REGISTRY NUMBER:
H11531

HYDROGRAPHIC TITLE SHEET

Locality: Approach to Port Canaveral

Instructions Dated: February 13, 2006 Project Number: OPR-H320-RU-06

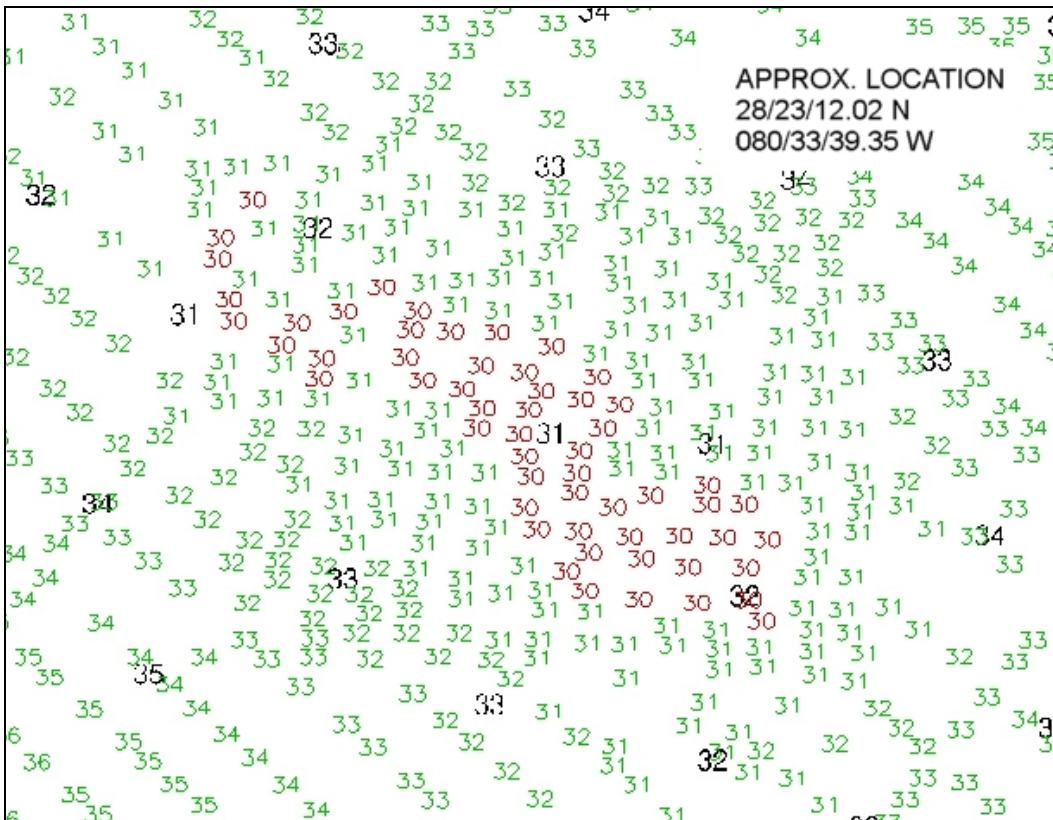
Agreement with chart 11476 was adequate with current soundings agreeing to within 2-feet of charted with the following exceptions:

By request of the Canaveral Pilots, a charted sounding of 31 feet was examined. Results show a shoaler depth of 30 feet as seen in the following figure: *Concur.*

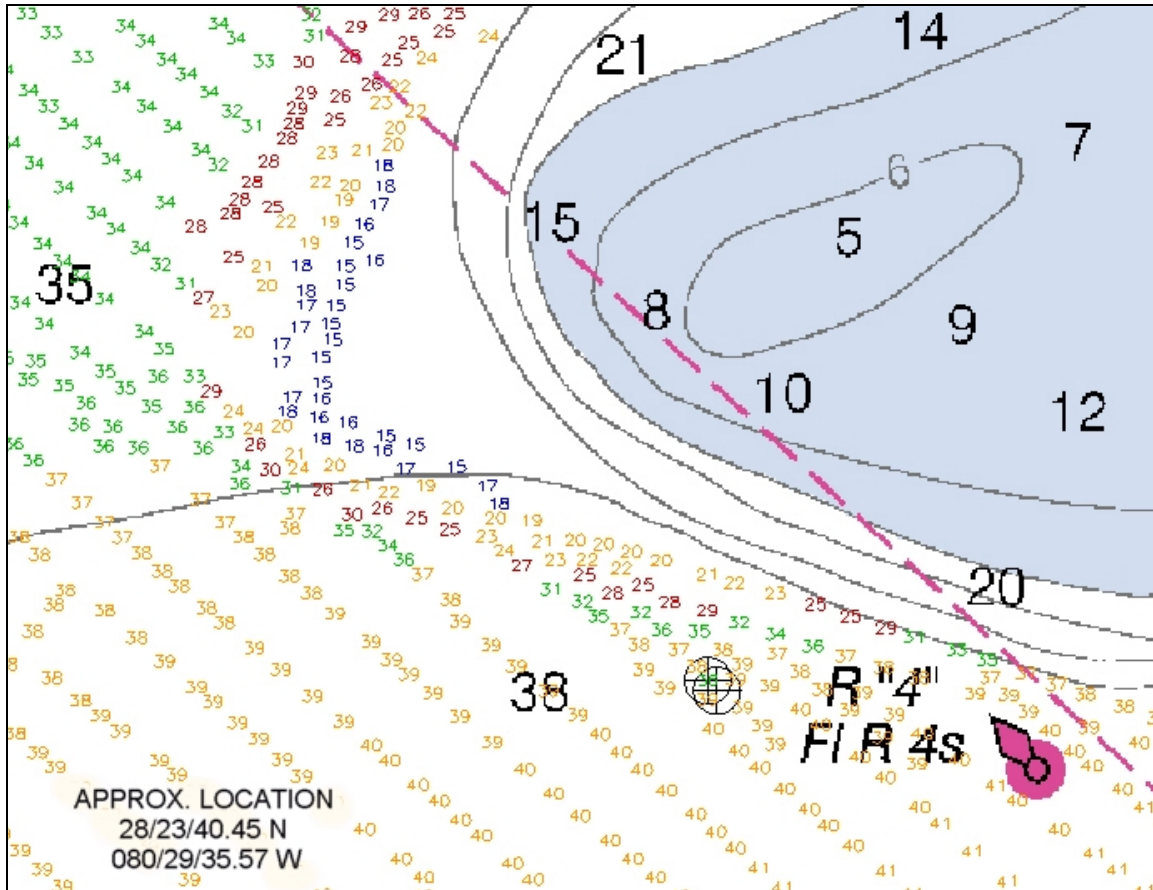
The charted shoal in vicinity of buoy R"4" Fl R 4s extends further west than charted to approximate location 28°23'40.45" N, 080°29'35.57" W as shown in the following figure:

Concur.
